**Ordinary Council Meeting**  
**25 September 2018**

# Lot 102, 182 Raby Road, Gledswood Hills

Planning Proposal

March 2018 | Revised Final

Figure 5: View looking south from the intersection of Gledswood Hills Drive and Raby Road

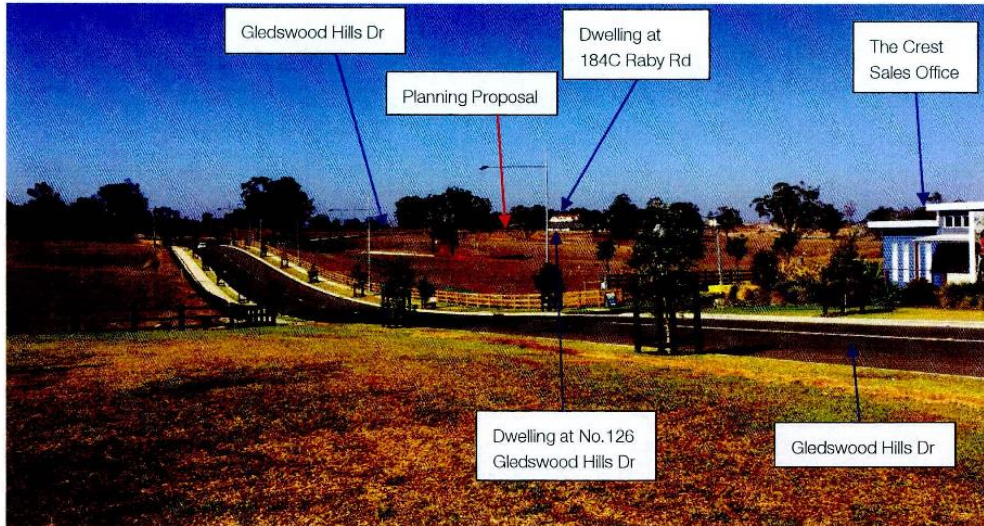
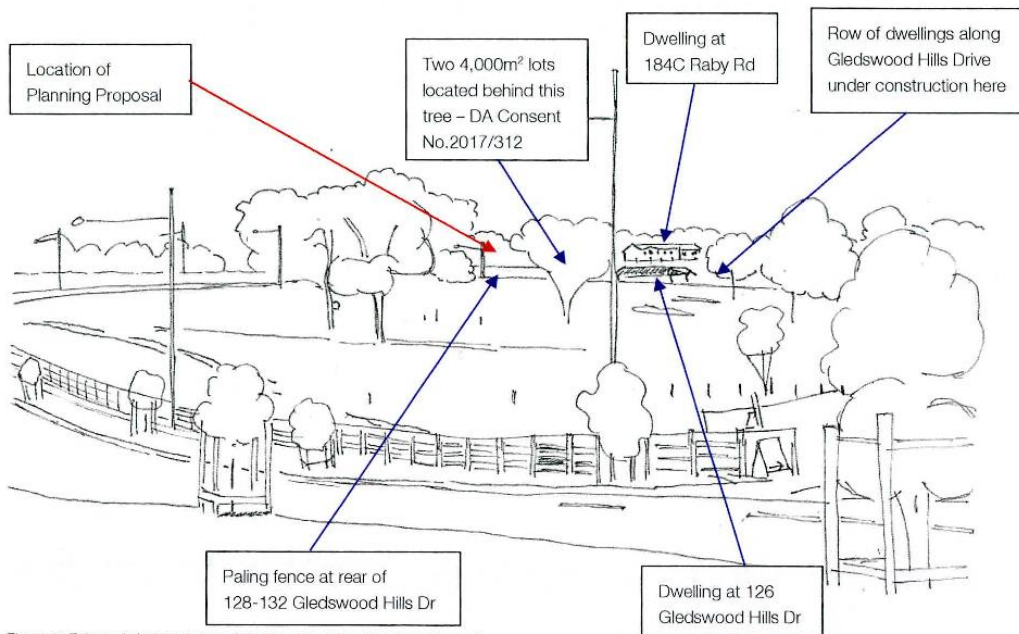
2. Diagram of existing buildings, likely future buildings on approved subdivisions and an indicative house on the proposed lot – to show will be in keeping with surrounding area.

When viewing the site from the north, adjacent to the Gledswood Hills Drive and Raby Road intersection, Council staff requested a diagram or sketch identifying the existing building and location of the future building on approved subdivisions. The photograph at Figure 5 illustrates the view from this current location.

The photograph of the view looking south toward the Planning Proposal from the Gledswood Hills Drive/Raby Road intersection in Figure 5 comprises:

The sketch at Figure 6 highlights these key features and the location of the Planning Proposal. The sketch has not endeavoured to show a dwelling on the site of the Planning Proposal, nor the two future dwellings to be built on the two new lots approved between the dwelling at No.184C Raby Road and the site of the Planning Proposal, as these dwellings will largely be obscured from view by the existing tree and paling fence that sit forwards of this land.

Figure 7: Aerial photograph of 17 Jan 2017 (Source: maps.au.nearmap.com)

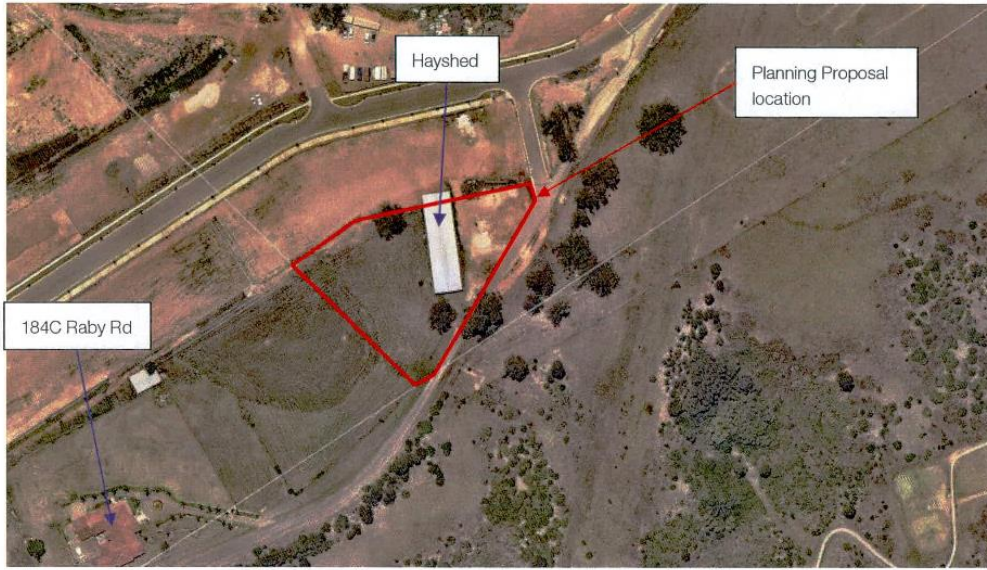
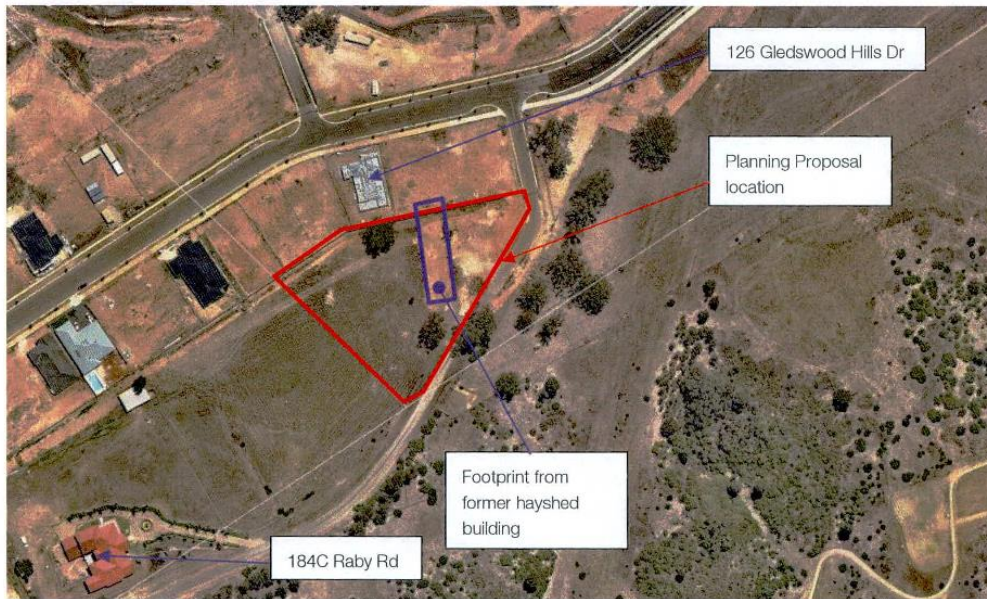
- 3. Updated justification within the Planning Proposal outlining that the proposal is a logical extension to the urban zone and the proposed lot is separate from the family holding.

A photograph of the former hayshed structure has not been located, however it is evident from the aerial photograph dated 17 January 2017 at Figure 1 and replicated at Figure 7, that the hayshed structure that stood on the site was of a significant scale.

It is evident from the aerial photograph from 21 January 2018 at Figure 8, the former location of the hayshed and its footprint in comparison to a new dwelling being built to the north at No.126 Gledswood Hills Drive.

**Figure 8** The subject property showing the current zonings and the areas of existing and proposed zonings. (Source: YSCO Geomatics Land Resource Consultants)

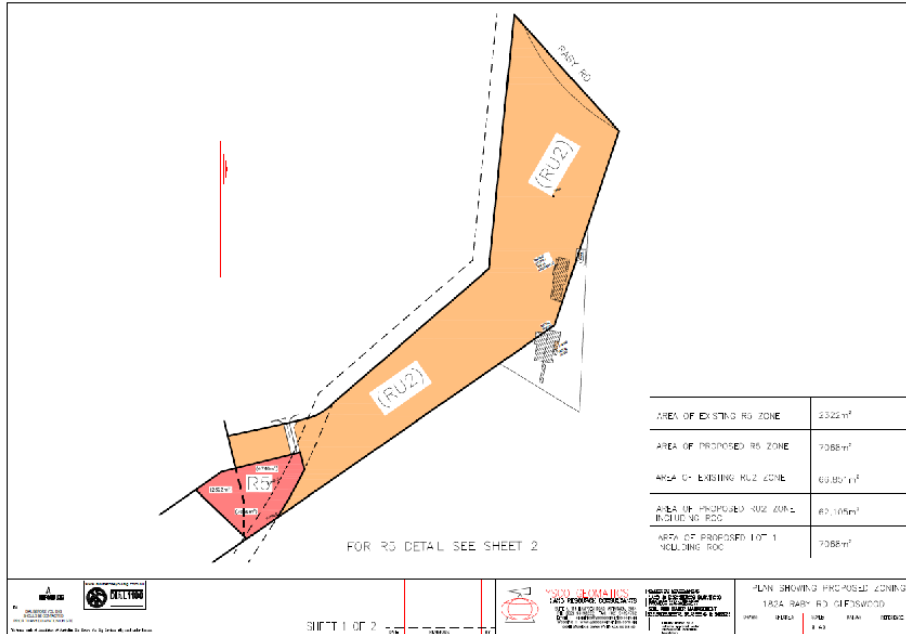
1. Demonstrate the locality of adjacent ridgelines relative to the subject site in the Visual Impact Assessment (VIA).
2. Provide a copy of the visual analysis study by LFA (Pacific) Pty Ltd referred to in the VIA for the subject proposal.
3. There are inconsistencies between the proposal and the supporting technical studies in relation to the area of the proposed R5 zone. It is requested that the proposal and studies provide a clear indication of the size of the proposed R5 area. Specific attention is drawn to Figures 3 and 4 in the Ecological Assessment and Figure 8 in the VIA.

3. *There are inconsistencies between the proposal and the supporting technical studies in relation to the area of the proposed R5 zone. It is requested that the proposal and studies provide a clear indication of the size of the proposed R5 area. Specific attention is drawn to figures 3 and 4 in the Ecological Assessment and figure 8 in the VIA.*
